Avolites Ltd.

Engineering Change Notice

Title	Trimming the links on a Sapphire 2000 SMF pcb.
ECN Number	ECN-0137
Equipment	Sapphire 2000 consoles with the following serial numbers :- 2117 to 2130
Author	Alwyn Fernandes
Drawing Number	None
Date	20/04/2001

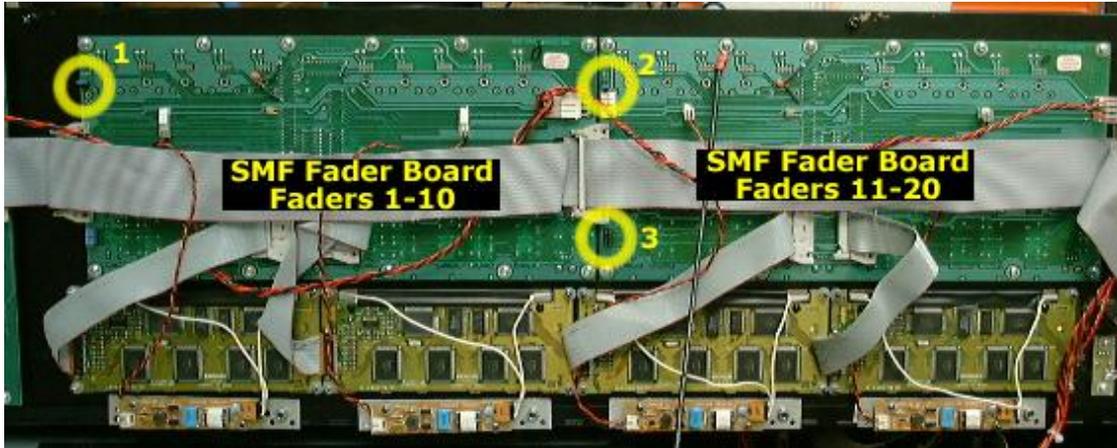
Reason for ECN	Console locks when pressure is applied to the Master/Memory Fader Panel because links short to drawer cover, especially since this has been raised to improve clearance for the graphic tablet.
Special Parts required	none
Special Tools required	a pair of wire cutters

The picture below shows where the three links on the SMF boards are located. All the exposed pins on these links should then be trimmed in half using a standard pair of cutters - see pictures below.
